WATERWHEEL BOOSTER STATION

SAWS Job No. 20-6008

ADDENDUM NO. 3

March 4, 2021

THIS DOCUMENT HAS BEEN PRODUCED FROM MATERIAL THAT WAS STORED, TRANSMITTED ELECTRONICALLY AND MAY HAVE BEEN INADVERTENTLY ALTERED. RELY ONLY ON FINAL HARD COPY MATERIALS BEARING THE CONSULTANT'S ORIGINAL SIGNATURE AND SEAL.

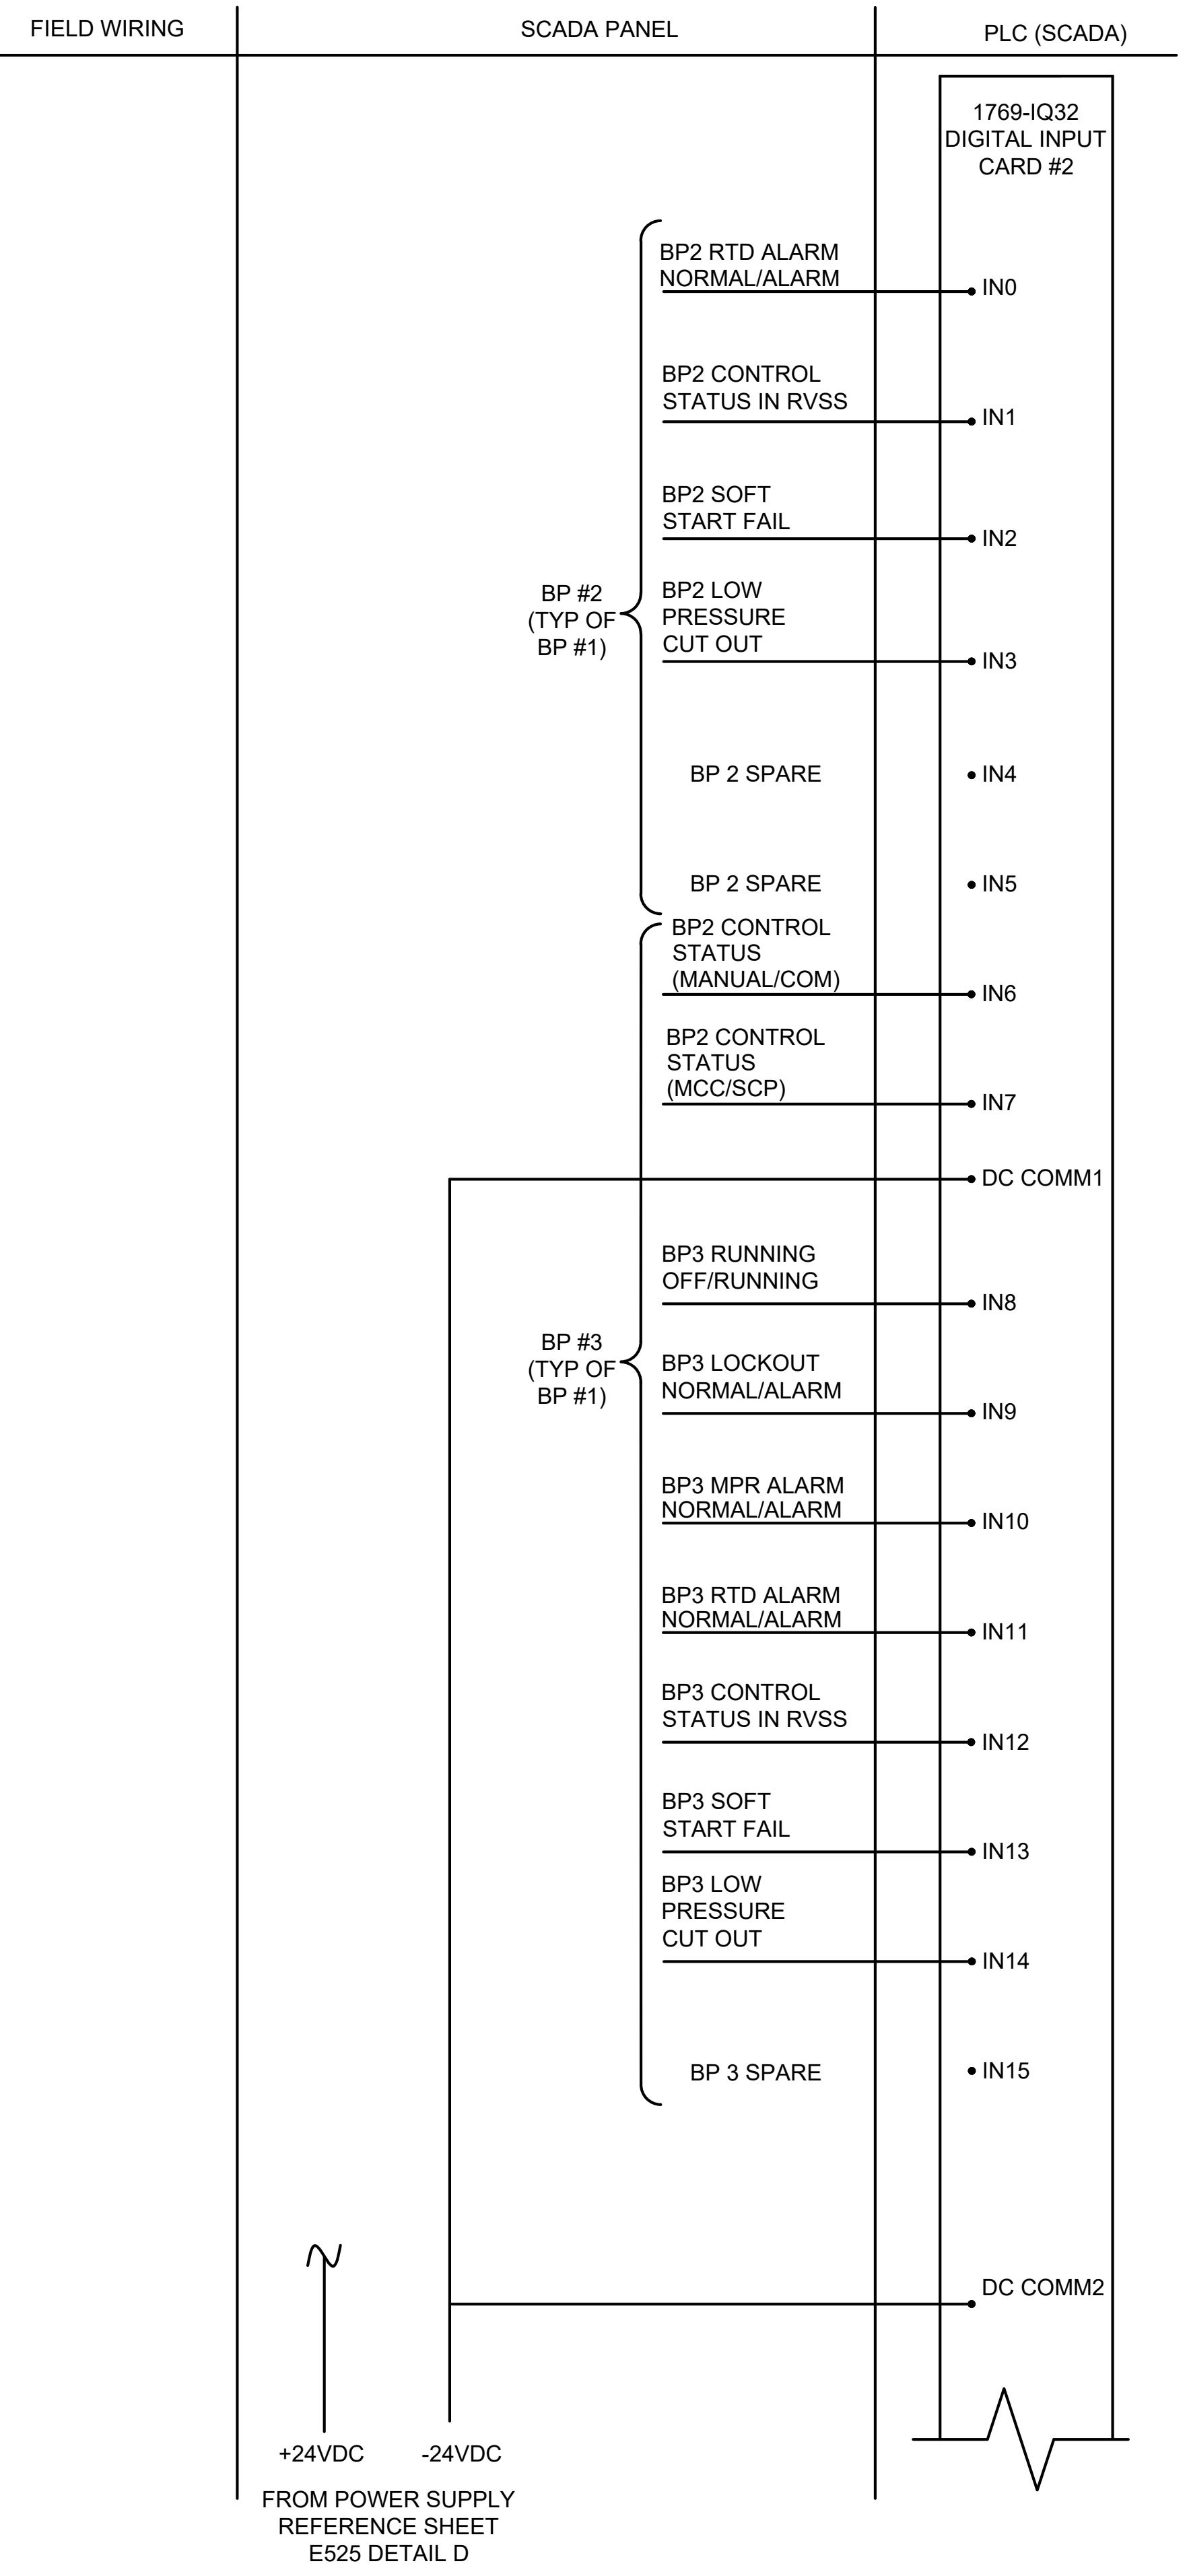
QUESTION 3: Please confirm a duct bank is to be run from new Control Building to Generator Slab. Provide any additional conduits or circuits that are required in addition to generator feeder to Bypass/Isolation Switch.

RESPONSE: It is confirmed that the duct bank is to be run from the new control building's bypass/isolation switch to the generator. See attached, revised sheet E2 for revised conduits and cables bypass/isolation switch and ATS is one unit. See attached, revised sheets E2 and E24 for any additional conduits/cables that are required in addition to the generator feeder to bypass/isolation switch.

1. Remove and replace sheets E4, E5, and E6, which have been revised to correct the scale.
2. Remove and replace sheets E2 and E24, which have been revised to show the correct feeder conduit and cable.
